# TOWN OF DANVILLE

**Danville Plan Commission  
January 10, 2024  
7:00 PM**

## **Penrose, Section 4, Final**

**Case:** 2023-2159  
Lennar Homes of Indiana, Inc., Petitioner  
Brett Huff, Kimley-Horn & Associates

# SECONDARY PLAT OF PENROSE SECTION 4

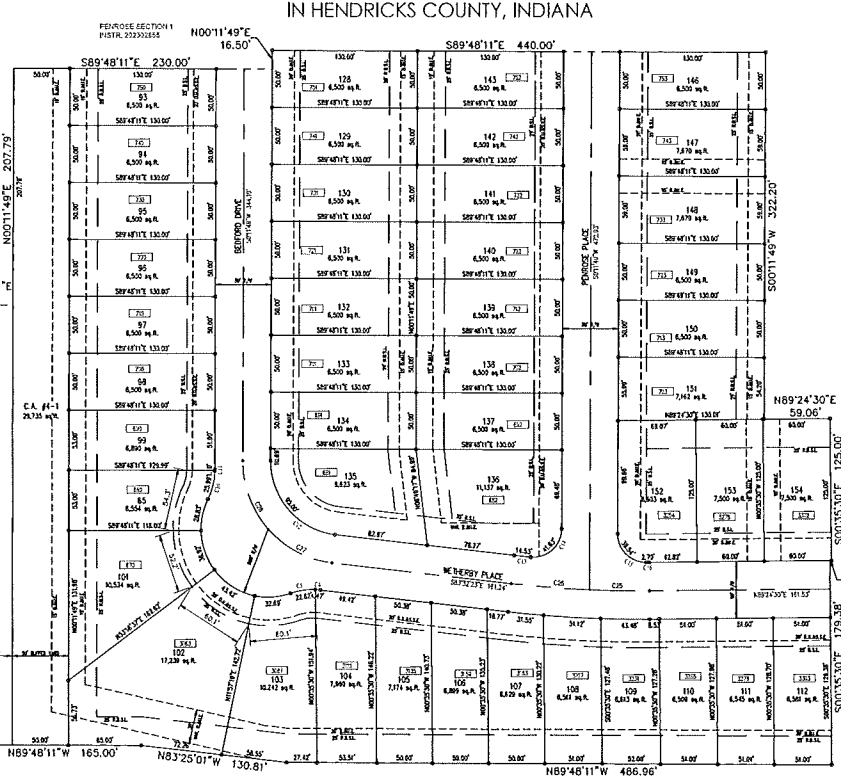
Staff held a Technical Advisory meeting with the developer and project engineer on November 21, 2023, and comments were submitted to the project engineer for revisions. The staff has reviewed the revised plans and has noted that Lot 100 is now Lot 65. The applicant must address the change in the lot numbering to make sure lot numbers are not duplicated.
